SHOREHAM NUCLEAR POWER STATION

SNRC-1101

Staff Queries Made During the Week Ending November 2, 1984
Regarding FSAR Chapter 13 - Conduct of Operations
Amendment No. 51 to License Application
Shoreham Nuclear Power Station - Unit 1
Docket No. 50-322

FIG. 13.1.2-2
 SHOREHAM NUCLEAR POWER STATION STAFF,
 OPERATIONS DIVISION
 SHOREHAM NUCLEAR POWER STATION - UNIT 1
 FINAL SAFETY ANALYSIS REPORT

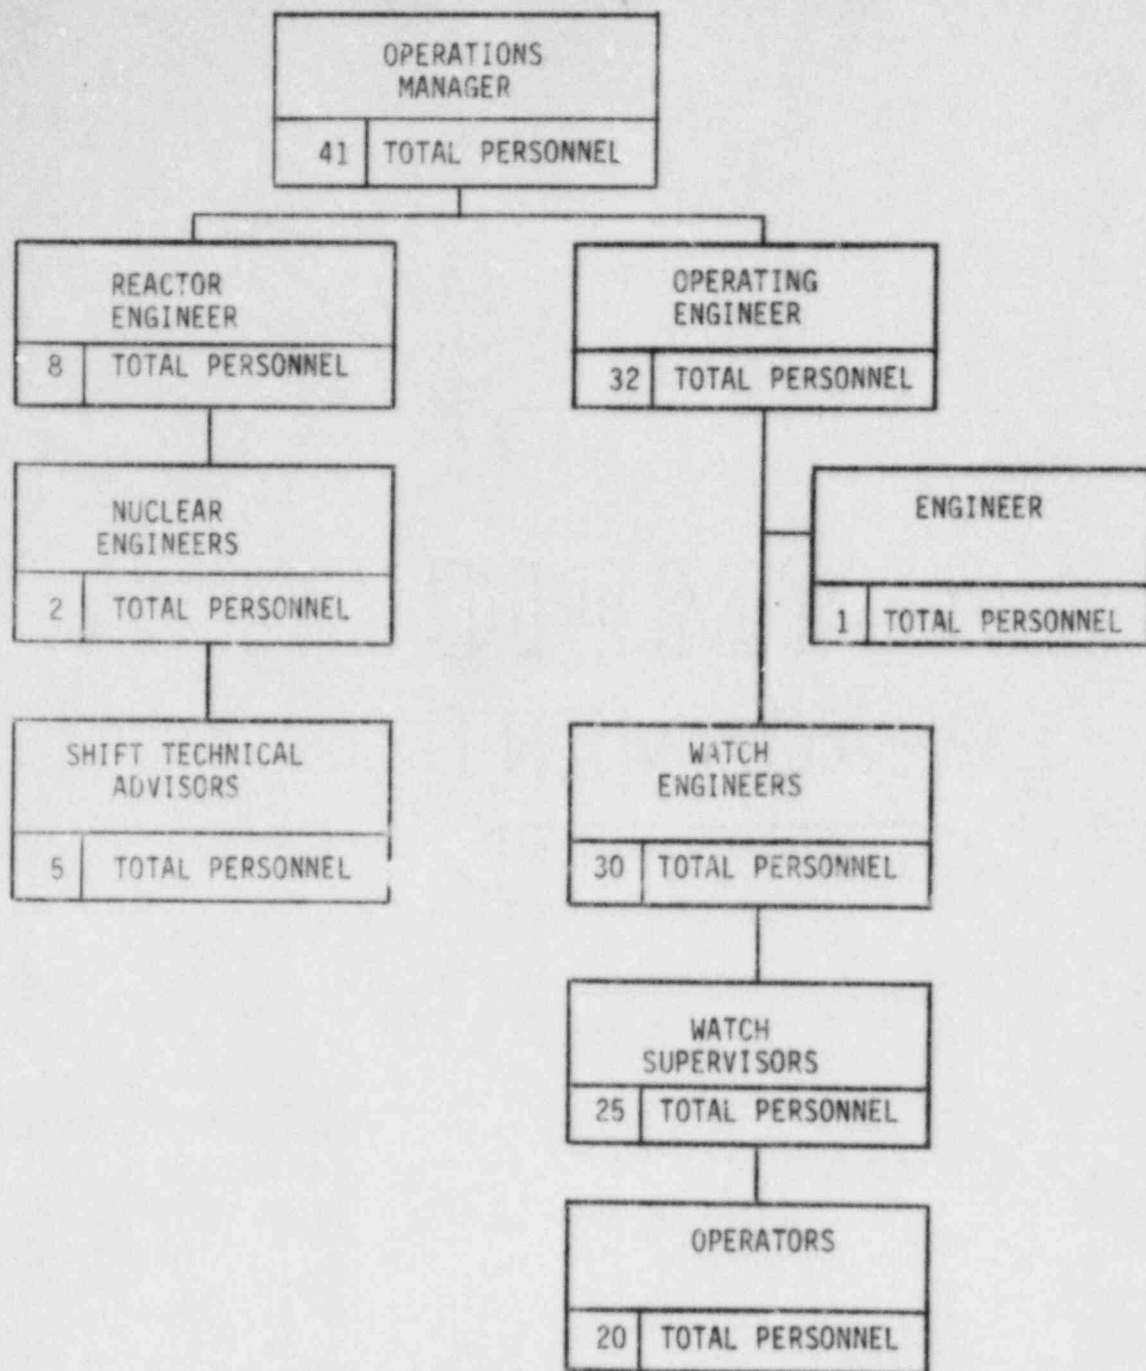
A revised version of FSAR Figure 13.1.2-2, Shoreham Nuclear Power Station Staff, Operations Division, is appended to this letter as Attachment III. This revision correctly shows the direct line of reporting of the Watch Engineers (each an SRO) to the Operating Engineer who is a licensed SRO. This revised figure reflects the organization as illustrated in the Final Draft of the Shoreham Technical Specifications and this revision of the figure will be in FSAR Chapter 13 in Revision 34, November, 1984.
